DeKalb County Planning Commission - Sketch Plat Hearing July 23, 2025 @ 6:00pm

STAFF ANALYSIS

Case No.:	P-Plat #1247029 (Robert Manor) Agenda # N1			
	Commission District: 4 Super District: 6			
Location/Address:	459 Ohm Avenue Scottdale, GA 30079			
Parcel ID(s):	18 047 21 001			
Request:	Subdivision to construct three (3) single-family detached dwellings.			
Property Owner(s):	Dallas Street Lofts, LLC			
Applicant/Agent:	W. Barry Dunlop			
Acreage:	1.05 acres			
Existing Land Use:	Vacant

ROBERT MANOR Sketch Plat - AP # 1247029

S2

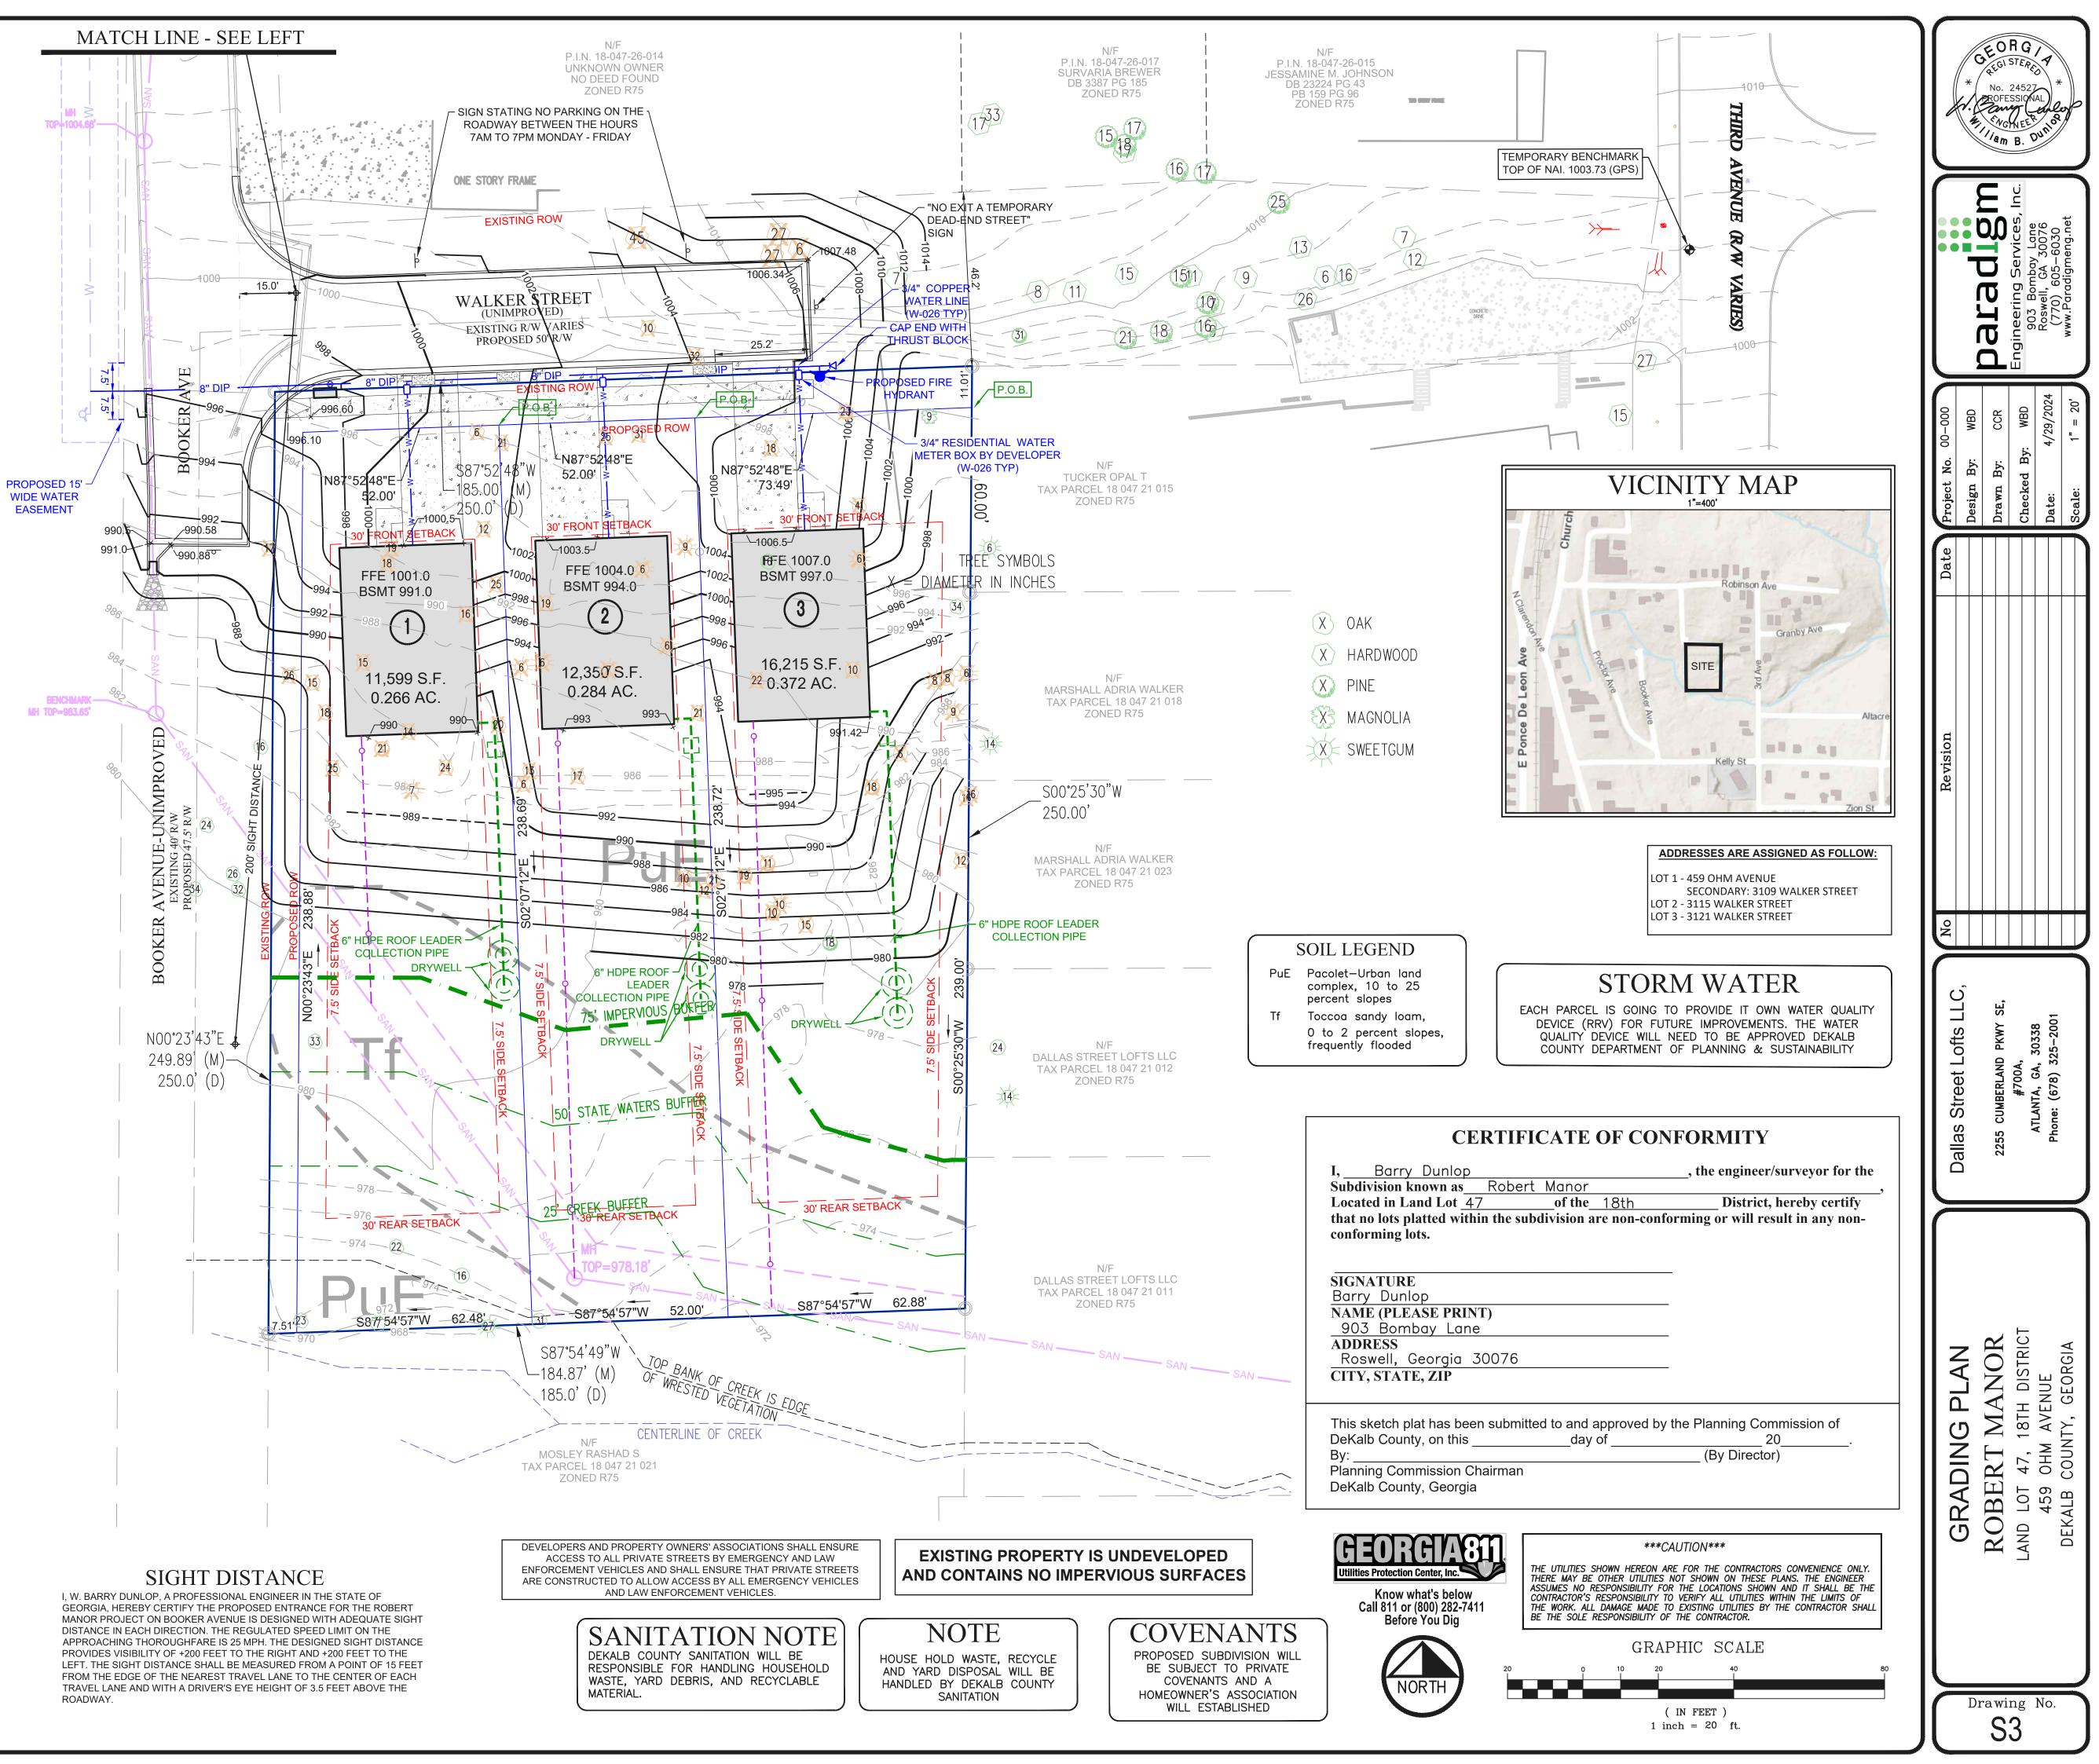
Notably, however, the improvement and extensions of Walker Street and Booker Street do not go to the fullest extent parallel to the development site frontages. Section 27-3.36.9. of the *Zoning Ordinance* requires that "the existing street grid [in the Overlay] shall be continued where site conditions allow". There are natural features that

likely prohibit the full improvement/extension of both Rights-of-Way: there is a significant slope near the eastern terminus of the proposed Walker Street extension and there are State Waters that traverse the southwestern portion of the development site that would likely prohibit a full extension of Booker Street. As such, Planning Staff has determined that the proposed improvements, which include sidewalks and ADA ramp connections along the southern portion of Walker Street, are sufficient in their intent to provide further connectivity to the Overlay.

The nature of the development as infill does not require the creation of a stormwater detention facility to serve the entire subdivision. Each parcel will provide their own water quality devices to address runoff reduction volume. The plans in their current configuration have been administratively approved by Land Development.

State Waters traverse the southwestern corner of the development site; the planned improvements do not appear to encroach on this feature.

The proposal is consistent with the goals of the *DeKalb County 2050 Unified Plan* and is in compliance with all developmental standards of the *Zoning Ordinance*. All other regulatory reviews have been completed and approved (or conditionally approved). Therefore, the Planning and Sustainability Department recommends *Approval* of the submitted Sketch Plat application.
